UNITED STATES PATENT AND TRADEMARK OFFICE

Office Action Summary

10/706,788

LOGUIDICE, JOHN

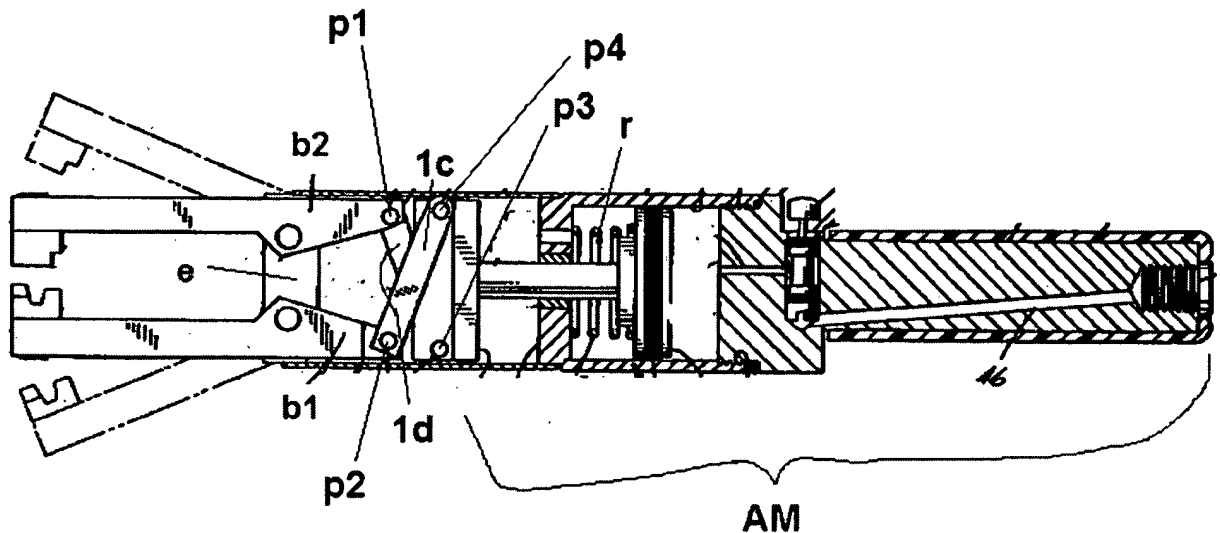
a) Regarding claim 1, Riera et al. disclose the same invention as the applicant, including a first engaging member (b1 below) configured to engage a clamp, a second engaging member (b2) configured to engage a clamp, a first interface member (1c) coupled to the first engaging member (at p2), a second interface member (1d) coupled to the second engaging member (at p1).

d) Regarding claims 10-12, Riera et al. disclose the same invention as the applicant, including a third interface member (e) wherein the third interface member is coupled to the first engaging member (b1) and the second engaging member (b2). Note that the third engaging member can be considered to be part of either the first engaging member (b1) (as in claim 11), or the second engaging member (b2) (as in claim 12), thereby coupling the first engaging member to the second engaging member.

e) Regarding claim 13, Riera et al. disclose the same invention as the applicant, including an actuating member (AM) configured to provide at least one of a first force and a second force.

f) Regarding claim 16, Riera et al. disclose the same invention as the applicant, including a first force applied to the first interface member and a second force applied to the second interface member by T-bar 98 in Fig. 4.

i) Regarding claim 19, Riera et al. disclose the same invention as the applicant, including a first engaging member (b1 below) configured to engage a clamp, a second engaging member (b2) configured to engage a clamp, an actuating member (AM) configured to provide at least one of a first force and a second force (to interface members 1c and 1d at pivot points p4 and p3, respectively), a first interface member (1c) coupled to the first engaging member (at p2) and the actuating member (at p4), a second interface member (1d) coupled to the second engaging member (at p1) and the actuating member (at p3), a reset member (r) configured to disengage at least one of the first engaging member and the second engaging member from the clamp, a first support member (p2) coupled to the first engaging member and the first interface member, and a second support member (p1) coupled to the second engaging member and the second interface member.

See MPEP § 2181. Riera et al. disclose the same invention as the applicant, including a first engaging means (b1 below) configured to engage a clamp, a second engaging means (b2) configured to engage a clamp, a first interface

means (1c) coupled to the first engaging means, and a second interface means (1d) coupled to the second engaging means.

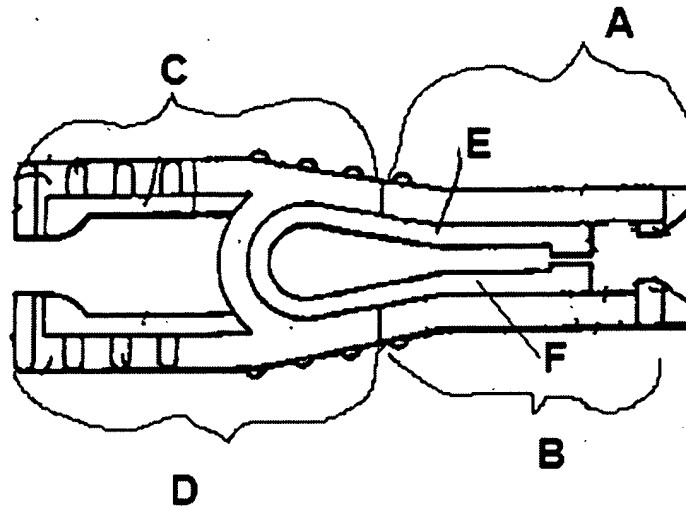
a) Regarding claim 1, Fischer discloses the same invention as the applicant, including a first engaging member (46) configured to engage a clamp, a second engaging member (17) configured to engage a clamp, a first interface member (30) coupled to the first engaging member, and a second interface member (15) coupled to the second engaging member.

b) Regarding claims 4-7, Fischer et al disclose the same invention as the applicant, including a reset member (50) configured to disengage at least one of the first engaging member and the second engaging member from the clamp (Page 1, col. 2, Ins. 19-26), wherein the reset member is coupled to at least one

(53) of the first engaging member (at 46) and the second engaging member, and wherein the reset member is coupled to at least one (at 52) of the first interface member (30) and the second interface member)
